Owner/Applicant  
**DCR/PHOENIX HOMES**  
Telephone # 723-9227  
Plan # 27M-47  
Project name WHITE TAIL RIDGE  
Civic Address: 173 FRANK FISHER CRES  
House model: KINGSWOOD M  
Bldg. Ht. 8.43 m  
Lot coverage 11.6 %  
Scale 1:250  
Sod Area 2438 m<sup>2</sup>  
Asphalt Area 147 m<sup>2</sup>  
CHECKED/APPROVED BY: T.L.MAK ENG.

**LOT 147** **SITE/GRADING PLAN**  
WHITE TAIL RIDGE PH.IV

**Re: Proposed Single Family Dwelling, 173 Frank Fisher Crescent, Lot # 147 White Tail Ridge, Arnprior,  
Kollaard Associates File # 230020**

With regard to structural issues only, Kollaard Associates has reviewed the following drawings:

BASEMENT FLOOR PLAN EL. M

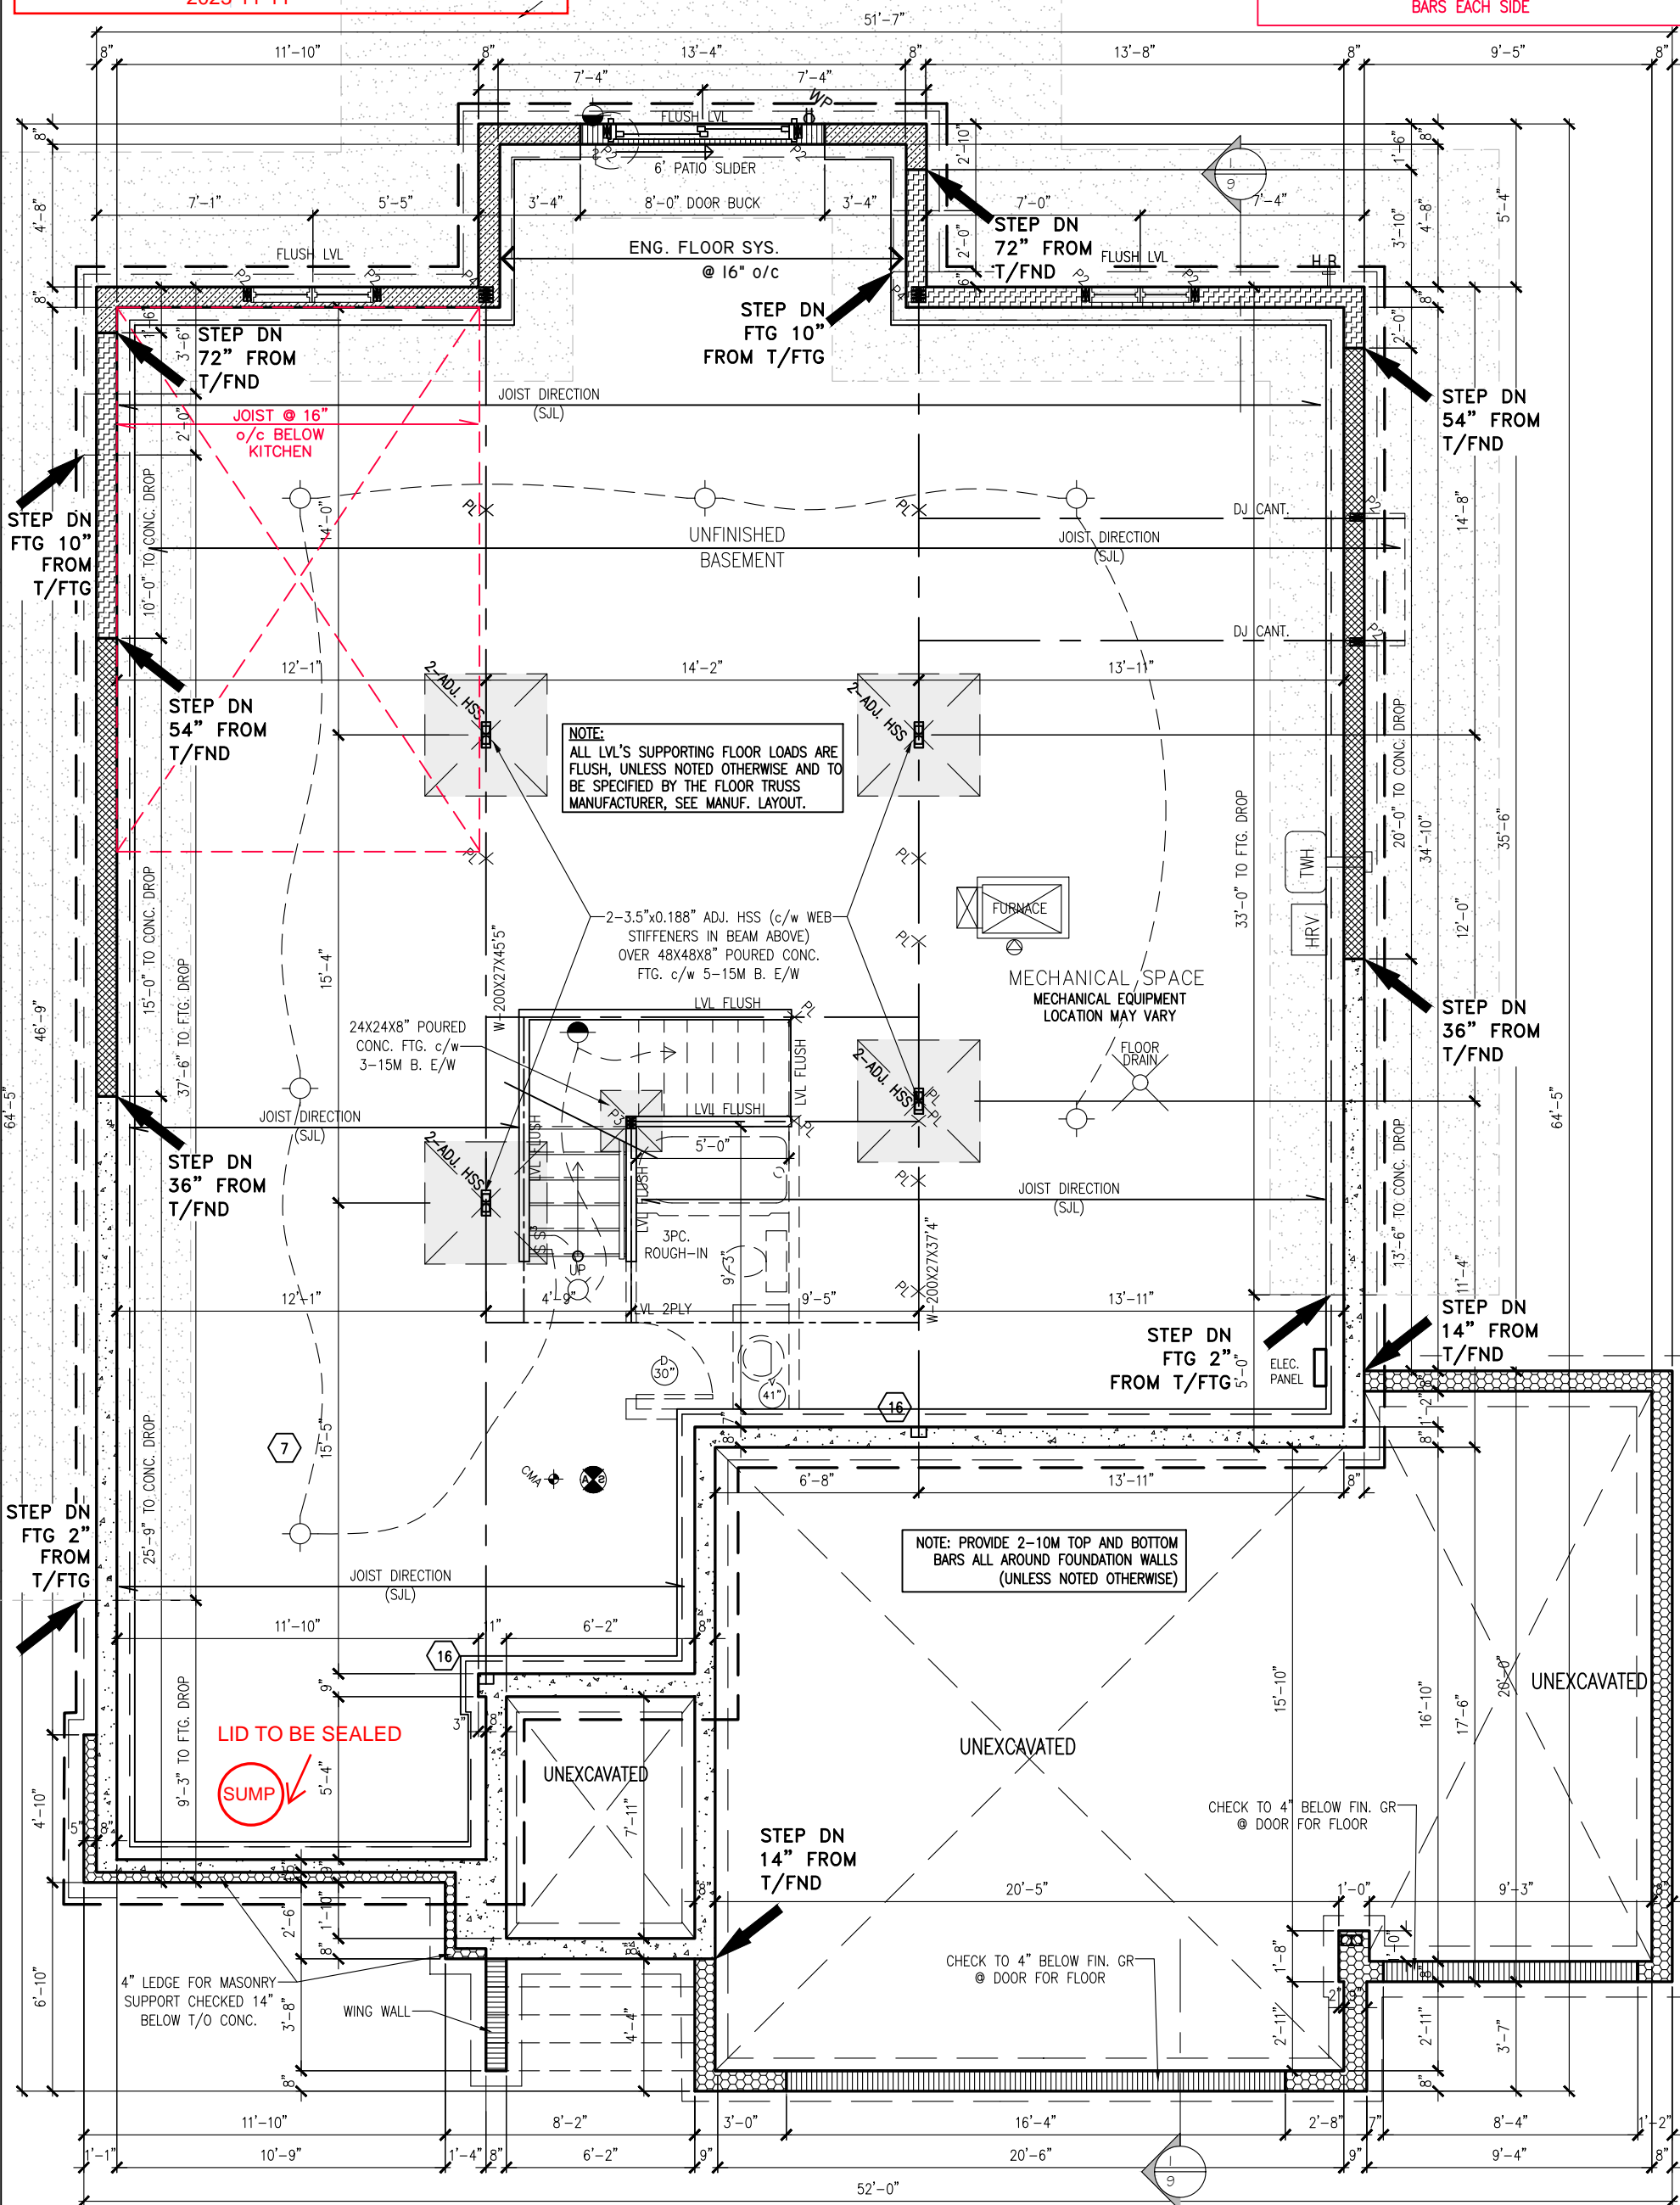
11. It is the opinion of Kollaard Associates that the proposed steel beams and posts shown on Phoenix Homes Sheet # 2M are adequate.
12. The front porch slab reinforcement described on Phoenix Homes Sheet # 1M is adequate.

13. As noted on Phoenix Homes Sheet # 2M, the framed walls supporting the intermediate landing may be supported by the basement slab.
14. The proposed 7'-10" foundation walls conform to 2012 OBC Table 9.15.4.2.A. ensuring that the grade difference between the basement slab and the exterior grade (including the garage slab) does not exceed 7'-6½".

15. The proposed stepped down foundation walls (ie. framed knee wall above) conform to 2012 OBC Table 9.15.4.2.A. ensuring that the grade difference between the basement slab and the exterior grade (including the garage slab) does not exceed 3'-11".

16. The proposed strip footings, interior pad footings and exterior pad footings shown on Phoenix Homes Page # 2M and noted on Phoenix Homes Sheet # 1M are adequate.

SECOND FLOOR PLAN ELEV. M

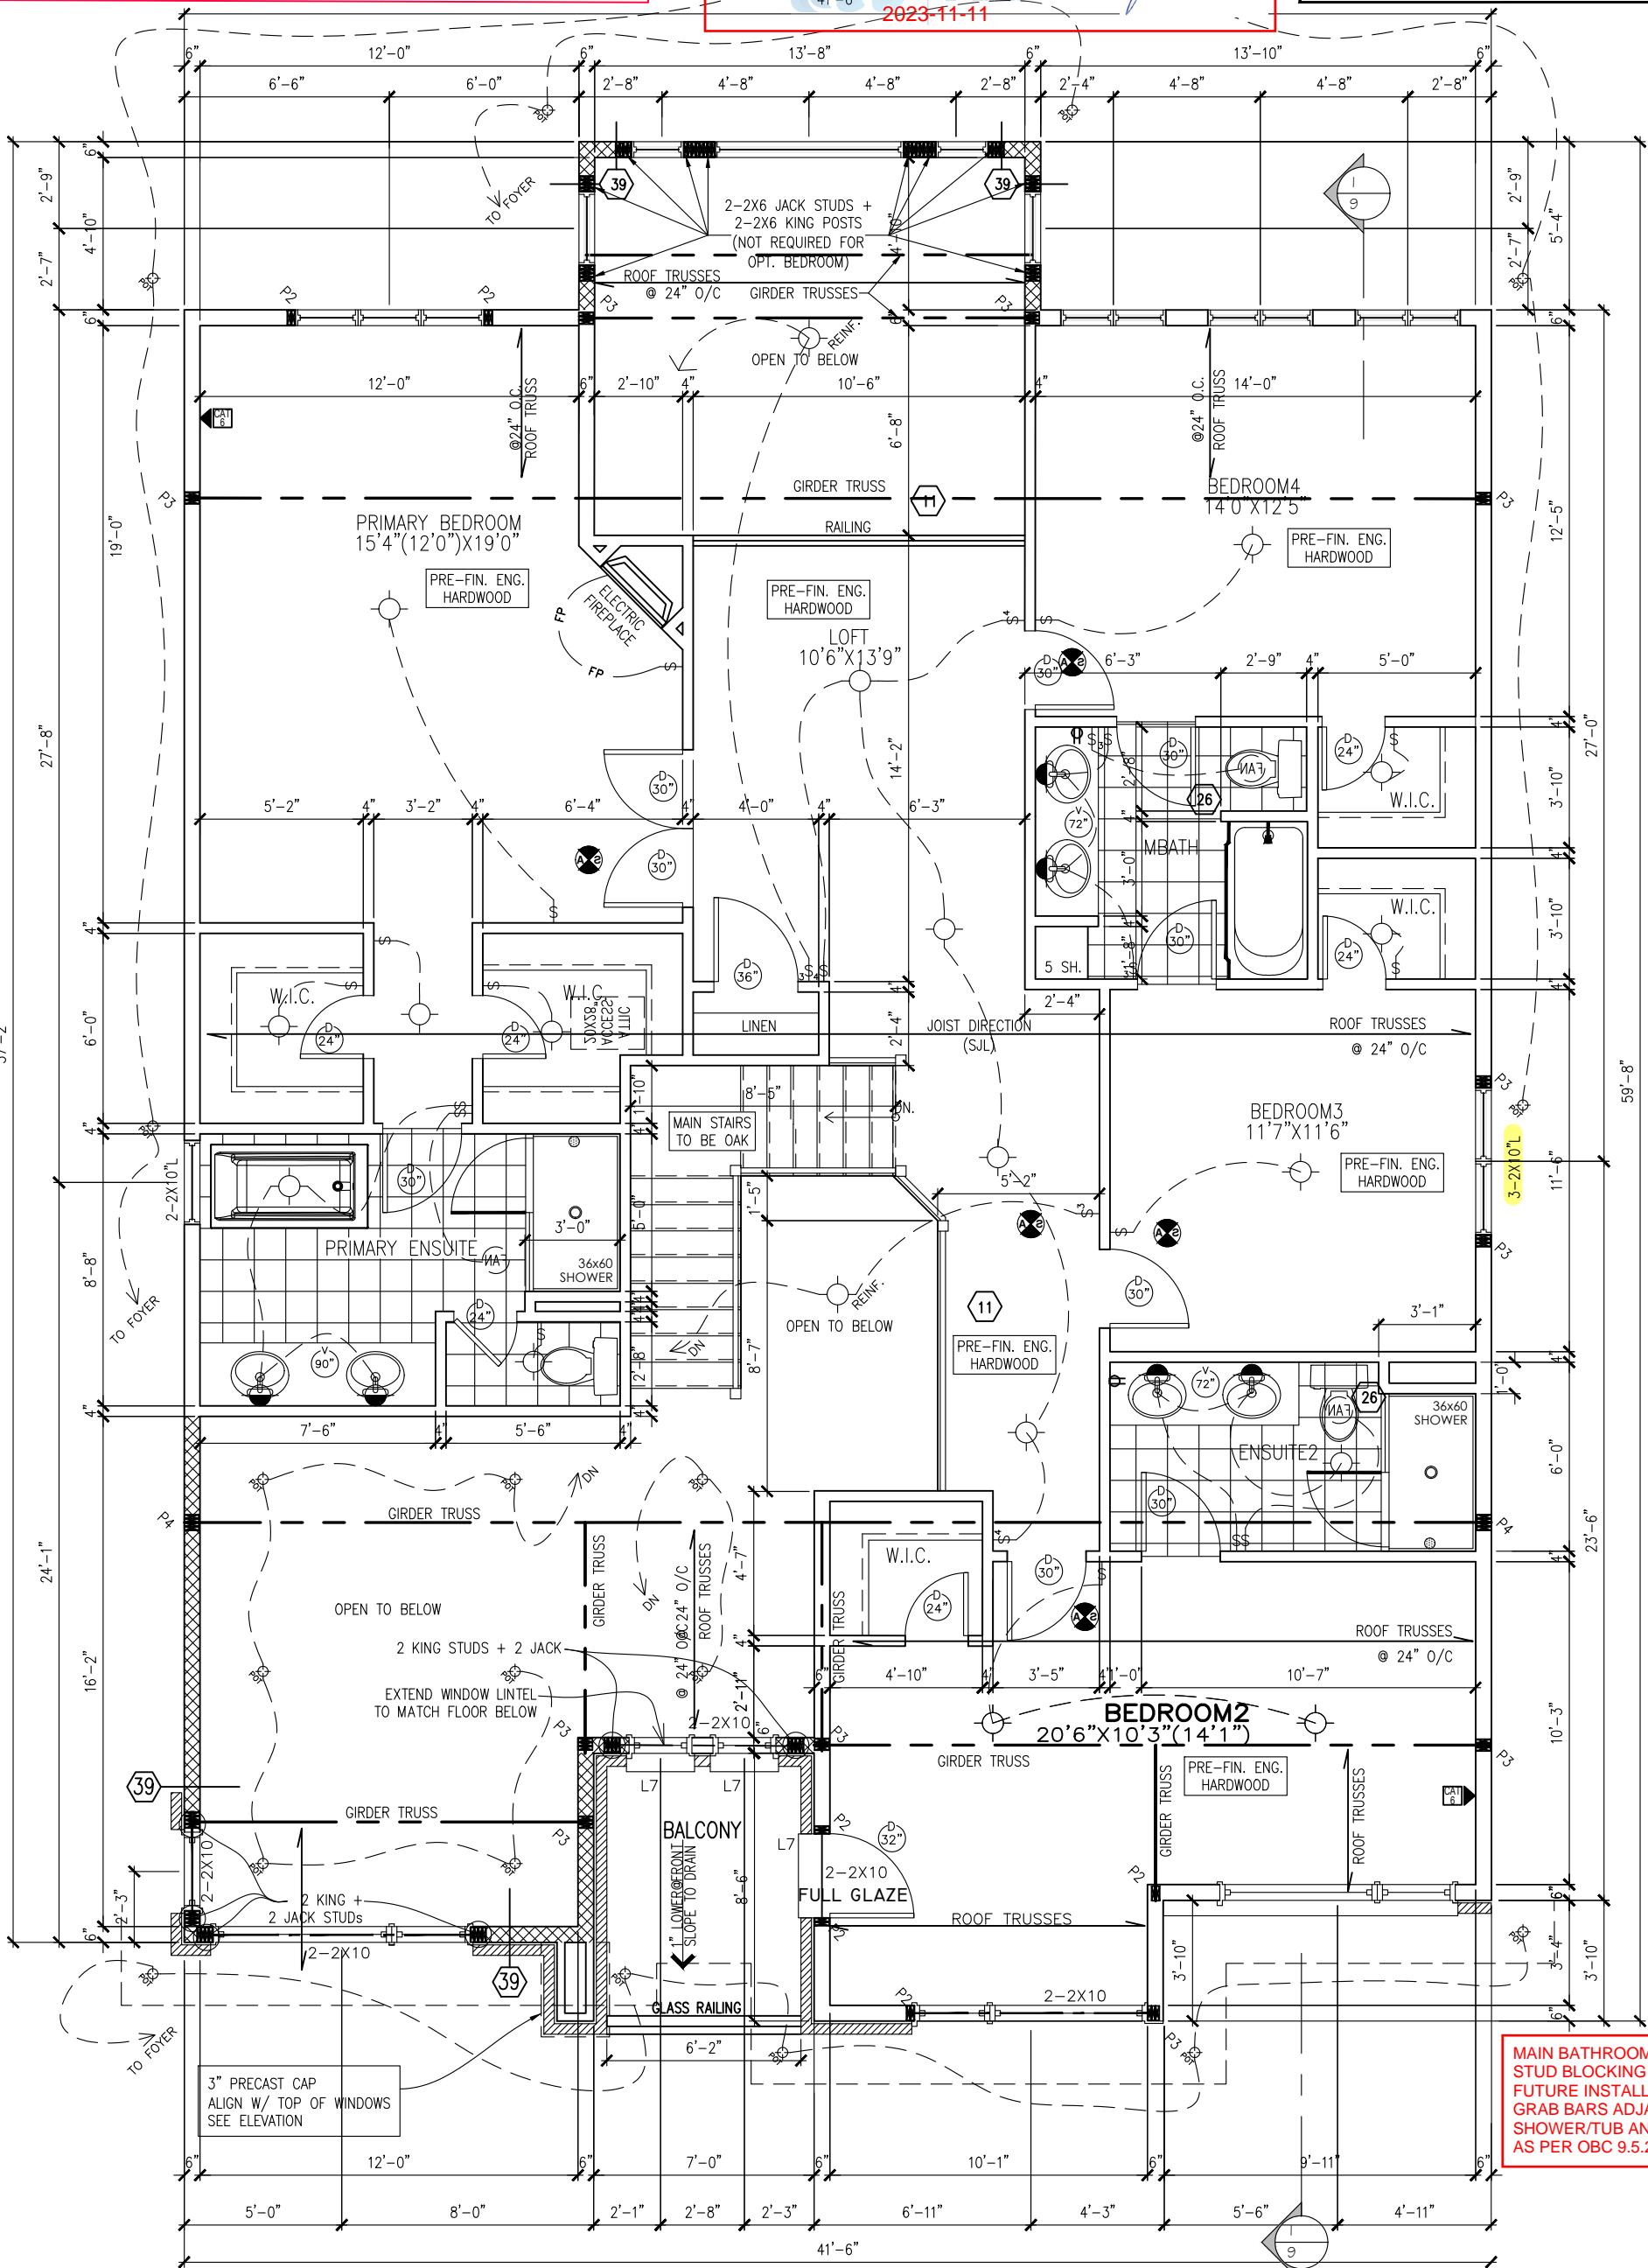
1. It is the opinion of Kollaard Associates that the proposed lintels and supporting posts shown on Phoenix Homes Pages # 4M are adequate.
2. The proposed tall wall noted on Phoenix Homes Pages # 1 is adequate.
3. Posts supporting girders may consist of built up 2x6 posts as indicated on Phoenix Homes Pages # 4M and are laterally supported by plywood or OSB sheathing (i.e. posts form part of sheathed exterior walls unless noted).
4. Truss design is by others.

SINGLE ANGLE CONNECTION DETAIL  
SCALE = 1"=1'-0"

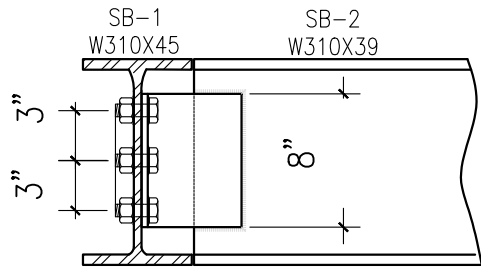
6. Ramset a 2x6 to the top flange of all steel beams to attach the above framing, floor joists and flush LVL beams.
7. The proposed single angle connection of two steel beams noted on Phoenix Homes Sheet # 8M is adequate.
8. Posts supporting girders may consist of built up 2x6 posts as indicated on Phoenix Homes Pages # 3M and are laterally supported by plywood or OSB sheathing (i.e. posts form part of sheathed exterior walls unless noted).
9. Truss design is by others.
10. Floor joist design and flush LVL beams within the floor structure are by the manufacturer.

SECOND FLOOR PLAN ELEV. C 1628 SF

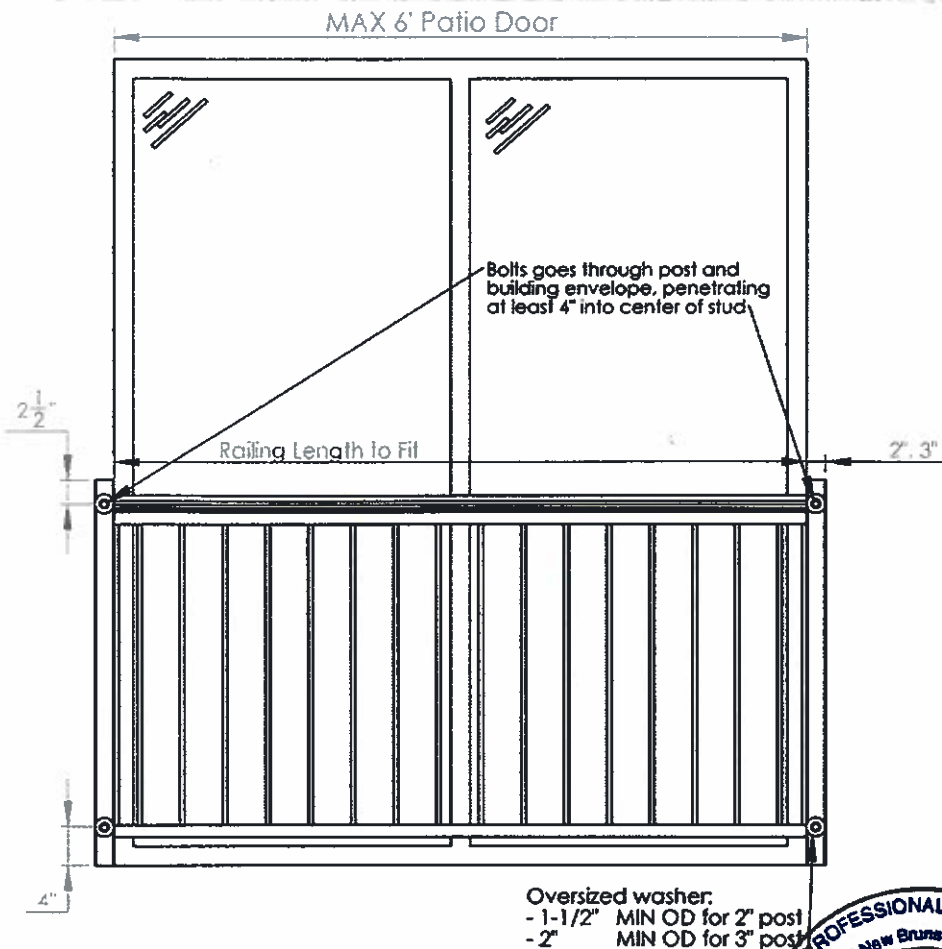
W.I.C. require supply air vent on exterior wall per 6.2.4.4.
